Village of Arlington Heights
Plan Commission
Board Room
Arlington Heights Village Hall
33 S. Arlington Heights Road
Arlington Heights, IL 60005
May 27, 2015
7:30 PM

- A. Northwest Crossings - 1421/1501 W. Shure Dr. - PC#15-007
Preliminary Plat of Subdivision

RE: CHRISTINA COURT SUBDIVISION-1306/1310 E. OLIVE ST. - PC#15-001

C3.0

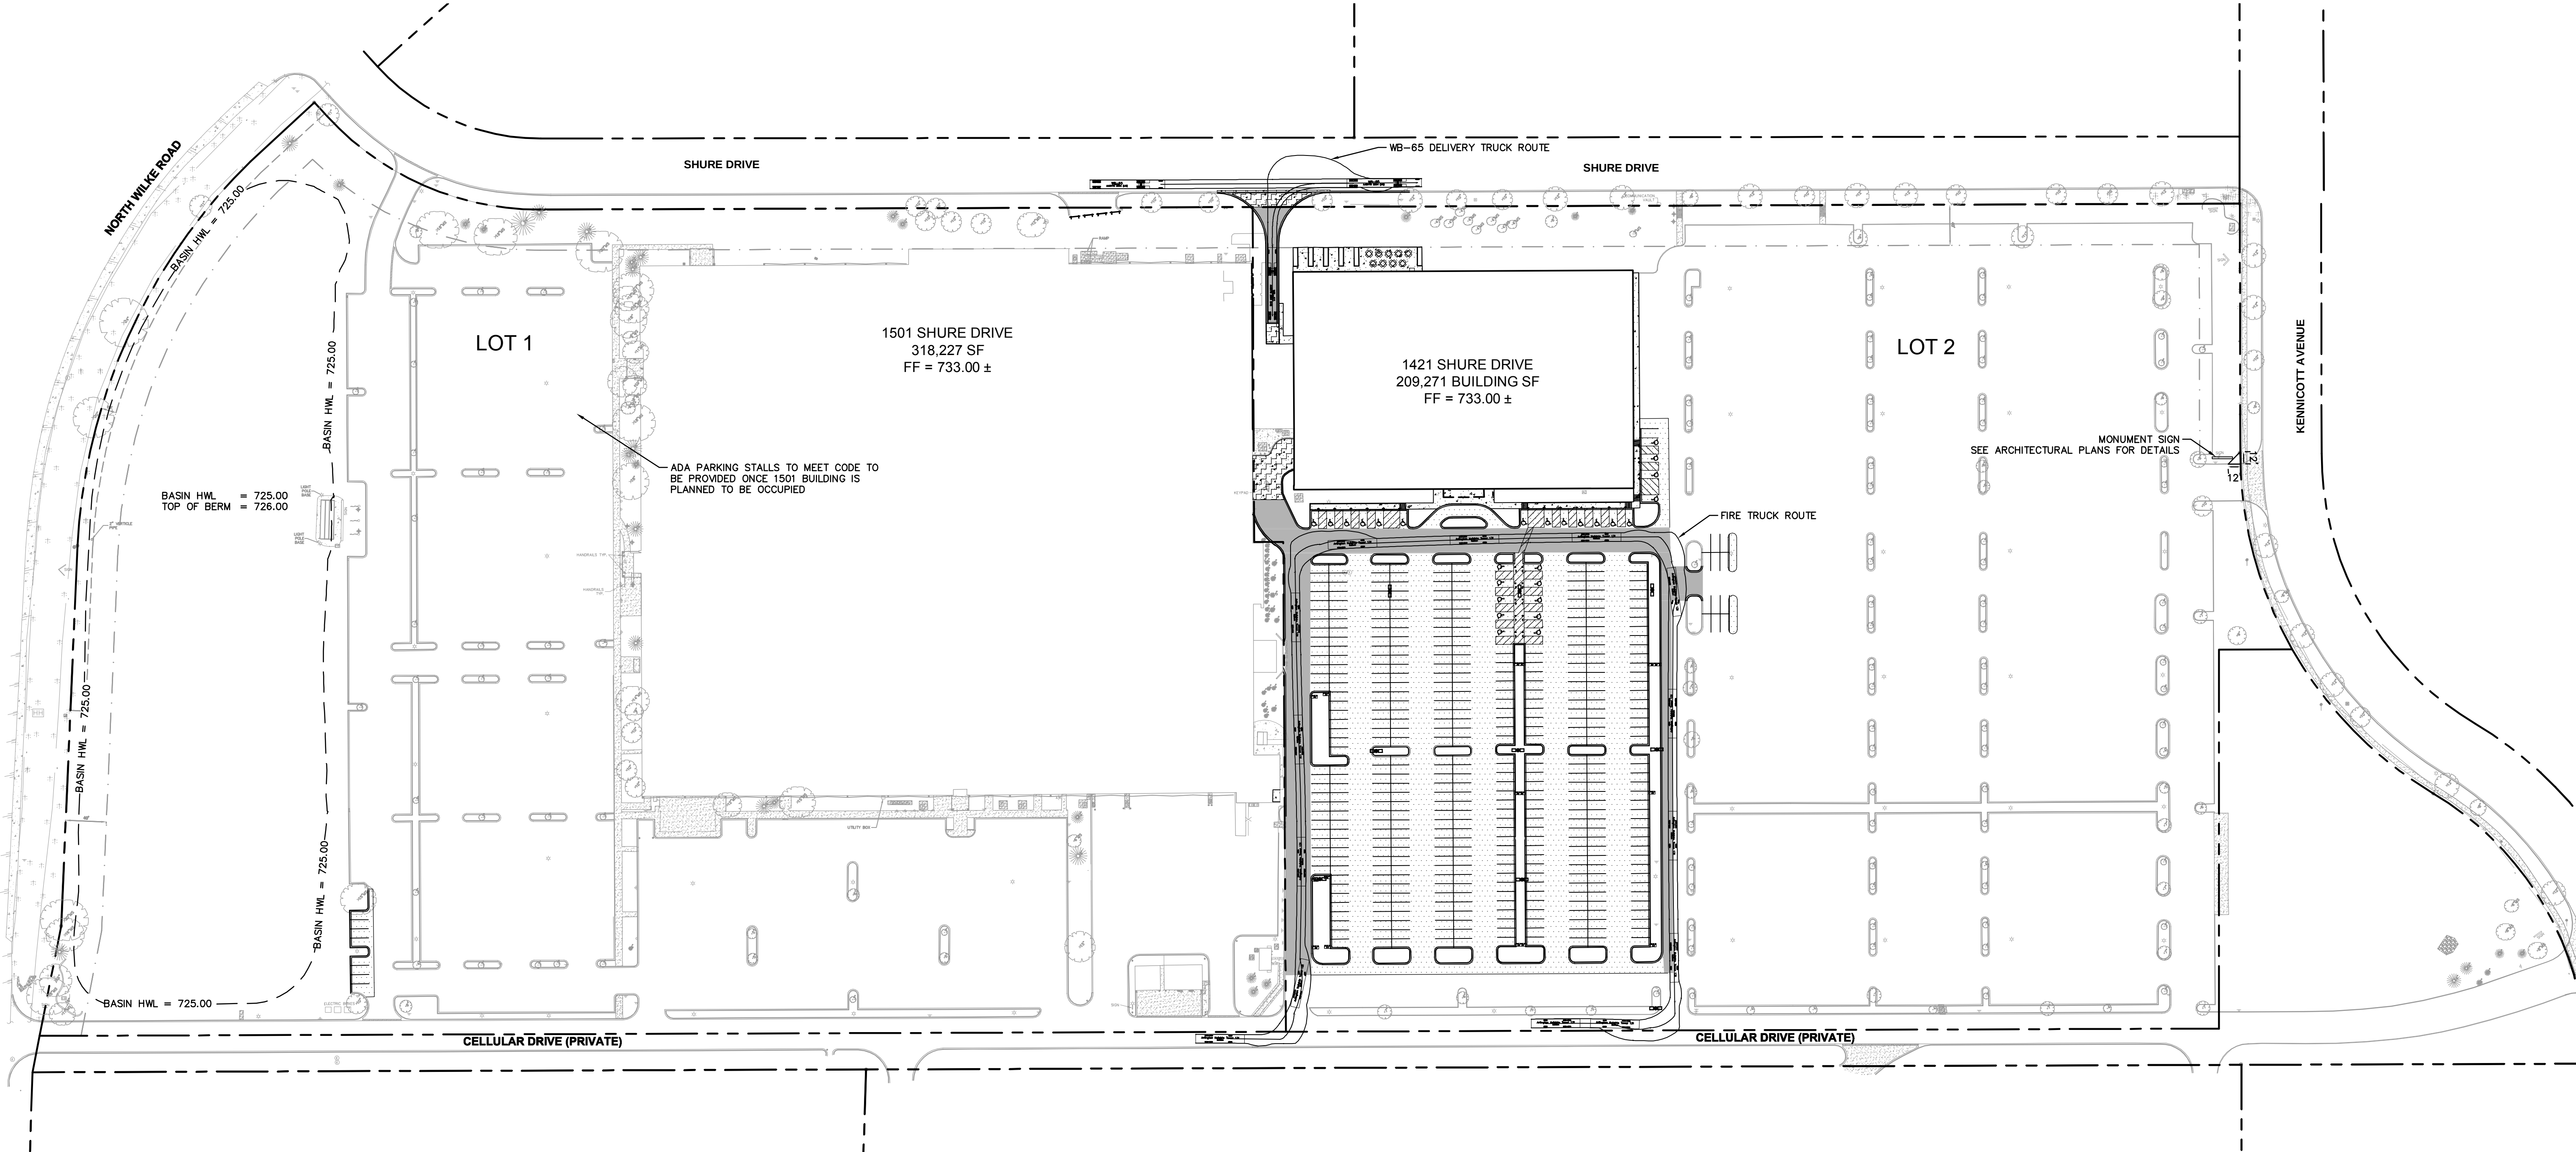
- 1) Show the corresponding location of all the Accessible Parking Spaces noted in the "Parking Summary" on Sheet C3.0.

Comment 1. Sheets A101 and C3.0: Show the corresponding location of all the Accessible Parking Spaces noted in the "Parking Summary" on Sheet C3.0.

Response: Truck turning exhibit for fire truck based on Village fire truck is shown on Sheet C3.0.

Response: The project is a PUD and we are requesting the signage presented be included in the revised PUD. The ground sign will be landscaped as required and will be out of the 12' visibility triangle. Reference Sheet C3.0 for location of sign with 12' visibility triangle shown.

Response: The required amount of ADA spaces will be addressed when improvements to 1501 Shure occur. 1501 Shure is currently unoccupied. The required number of spaces for 1421 Shure is shown on Sheet C3.0 and C3.1. 27 ADA spaces are required and 27 ADA spaces are proposed.
